## Model 281/288

## Clutch

An improved clutch is introduced in our assembly.

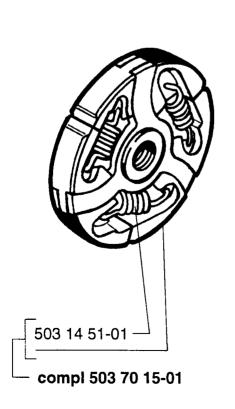
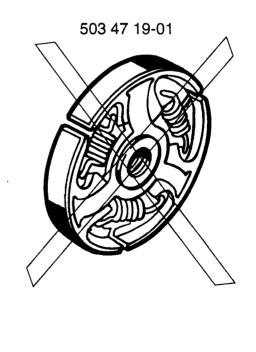
The clutch has the following advantages:

- ' Less slipping
- ' Same clutch spring as for model 3120 and model 394
- ' A protection over the spring in order to prevent damage on the clutch cover

503 70 15-01
 Clutch compl.
 503 47 19-01

503 14 51-01
 Spring (3120, 394)
 503 47 18-01
 R

Introduced from serial number: 281-4220001

288-4250001
